H. B. ROBINSON STEAM ELECTRIC PLANT, UNIT NO. 2  
DOCKET NO. 50-261  
LICENSE NO. DPR-23  
REVISION 1 - FINAL STEAM GENERATOR REPAIR REPORT  
REVISED FIGURES

ATTACHMENT 1  
REVISED FIGURE LIST

Revision No. 1 Instruction Sheet - Figure Changes

FIGURE 3.0-5, SHEET 2

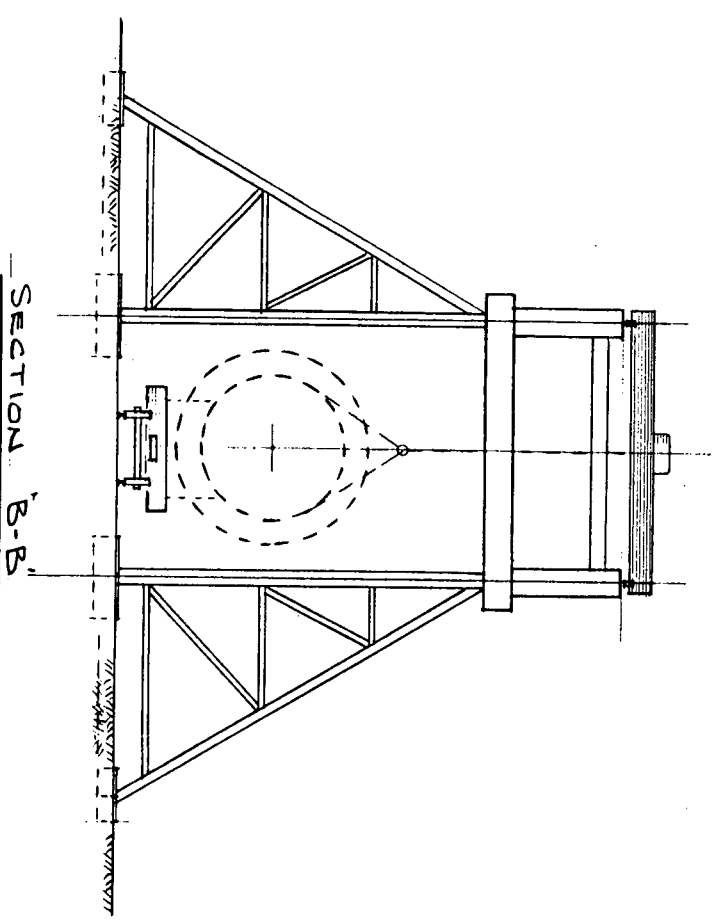
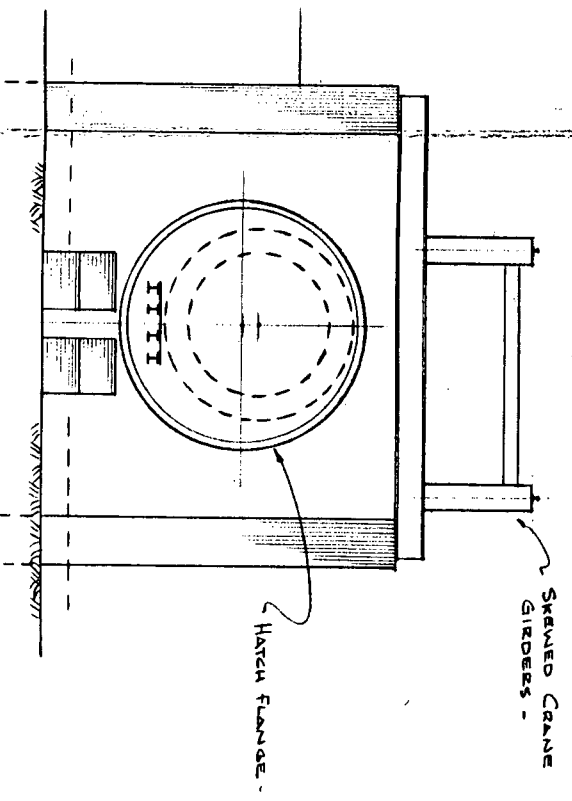
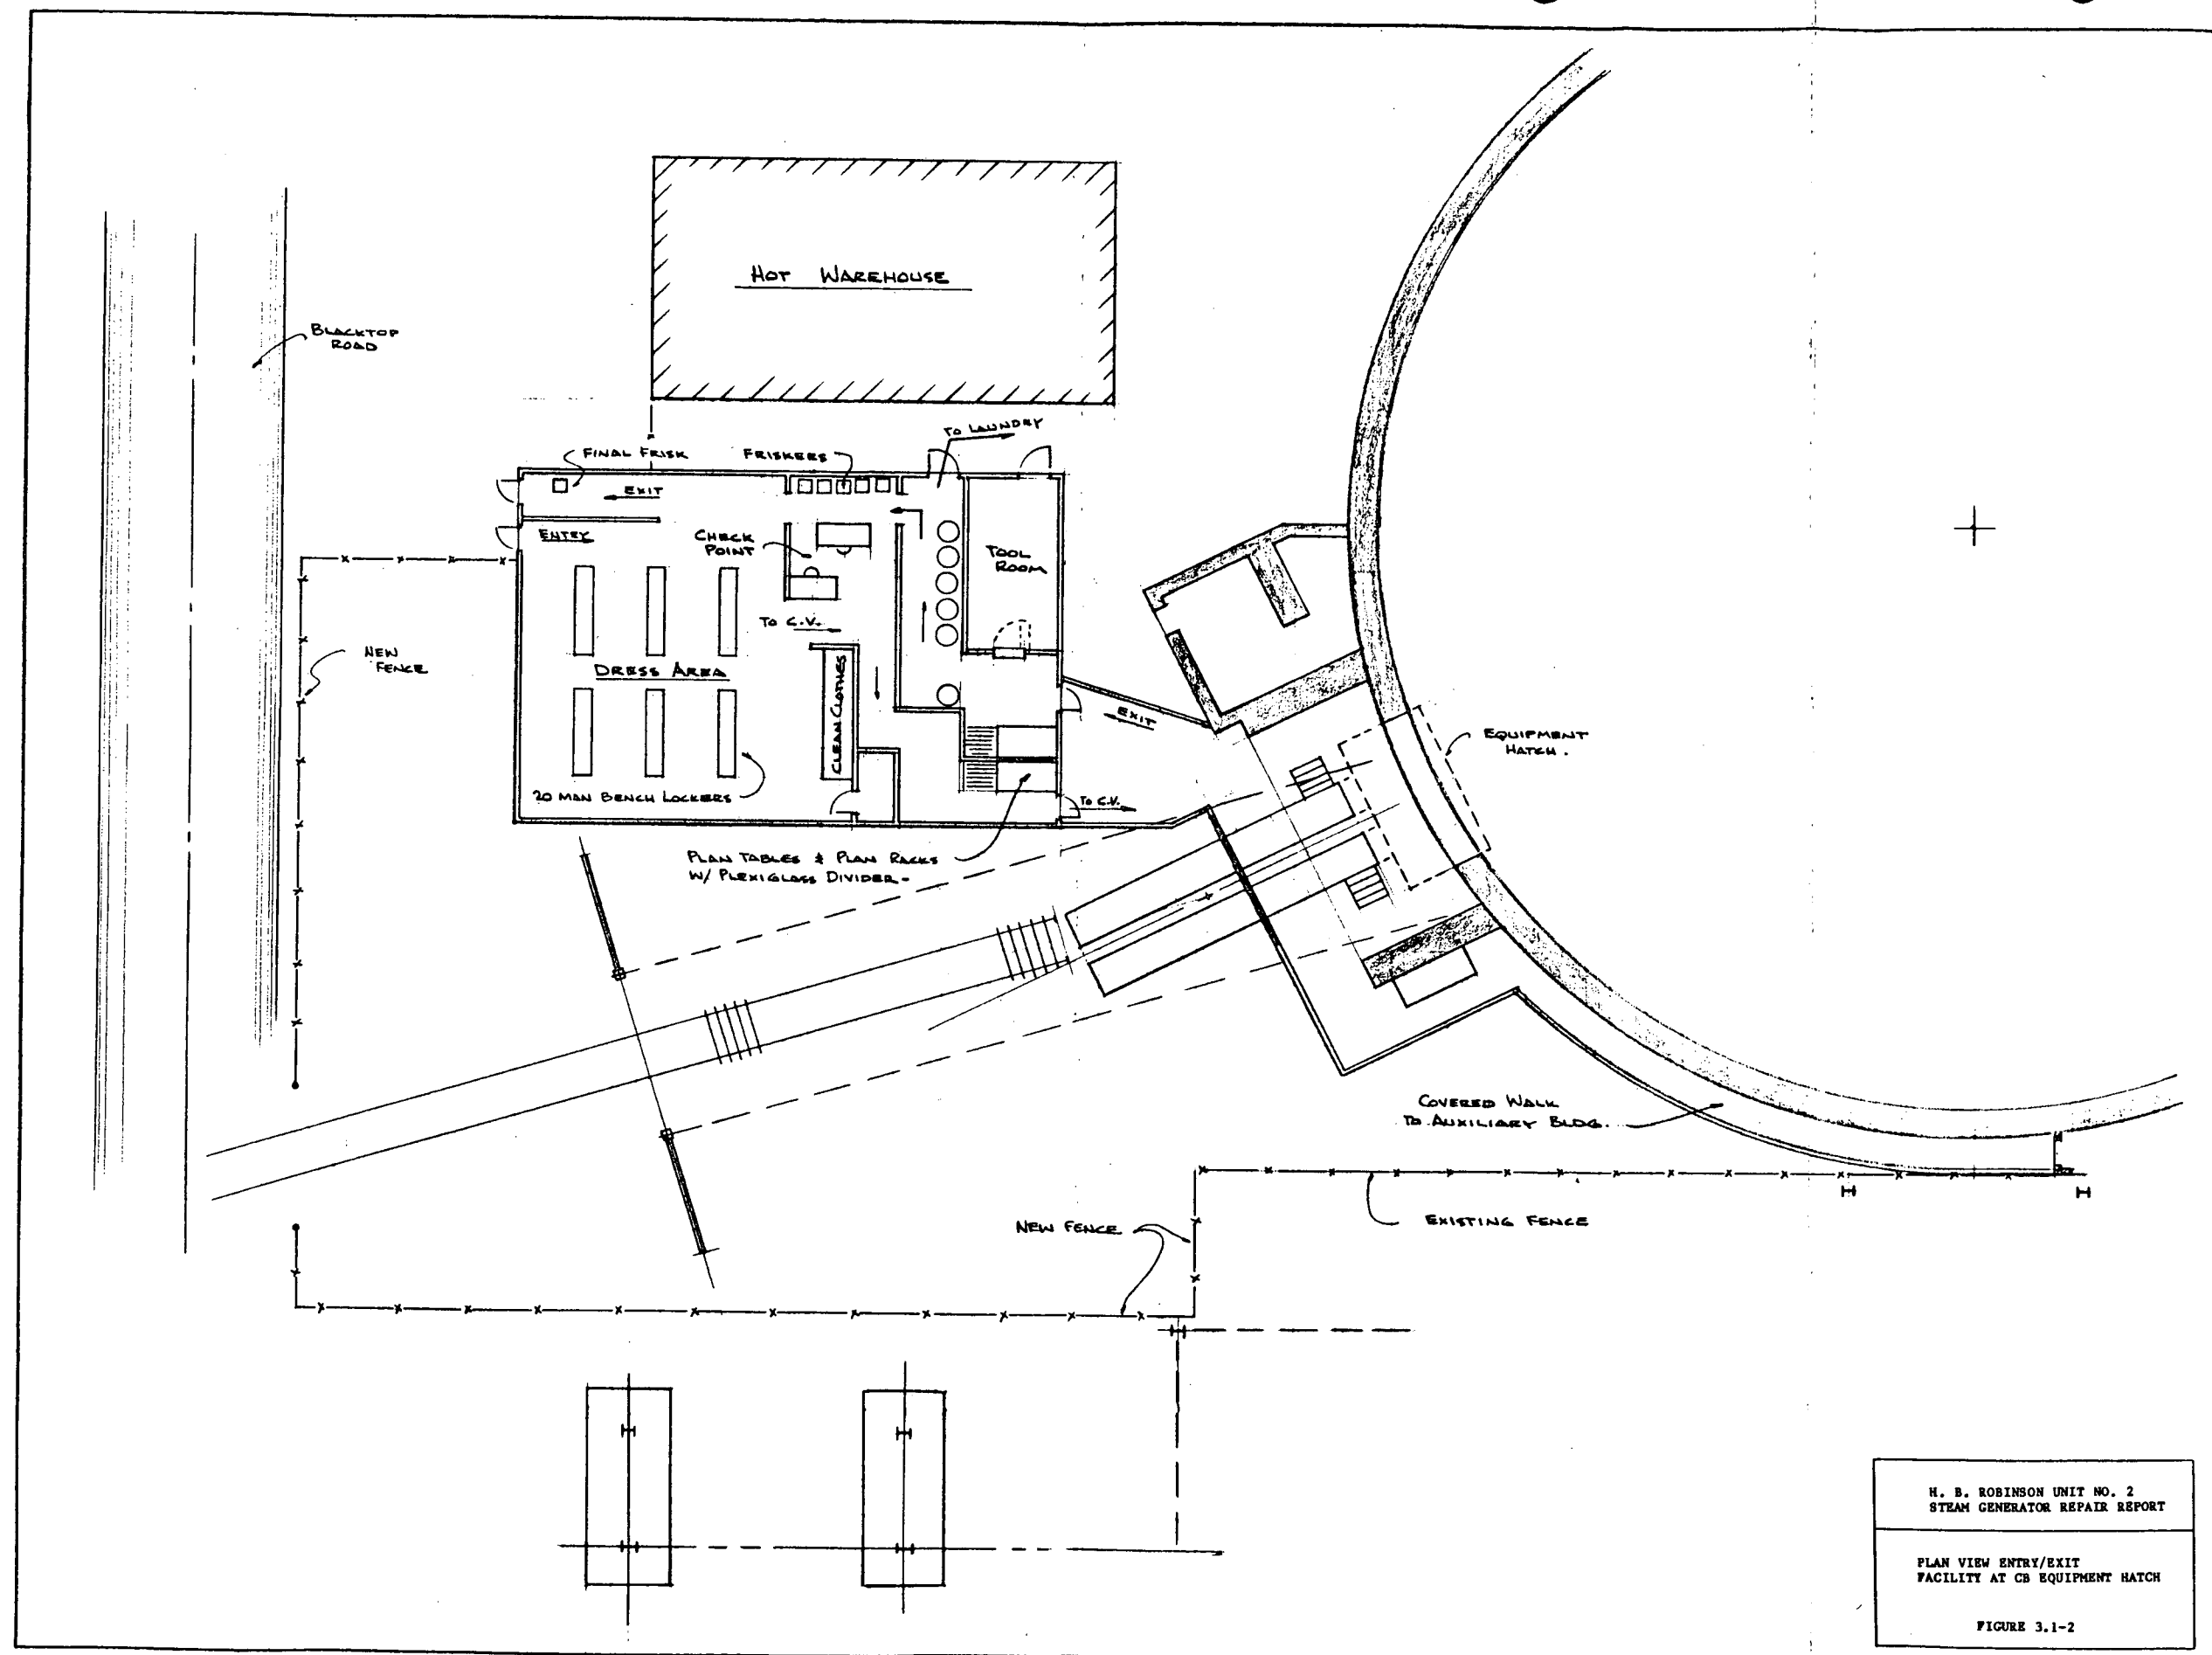
<u>Figure No.</u>	<u>Major Changes</u>
3.0-2	Removes upper dome from frames B through E. Adds upending/downending assembly and low profile saddles.
3.0-4, Sheet 1	Removes lifting frame assembly, revises design of transfer skid, and adds upending/downending assembly.
3.0-5, Sheet 2	Removes lifting frame assembly and adds a crane.
3.0-6	New drawing - Removal sequence for upper domes.
3.1-1	Revises location of new SG storage area and tomb. Revises site plan for new structures.
3.1-2	Removes dress out area due to new crane location, adds upper assembly storage stands.
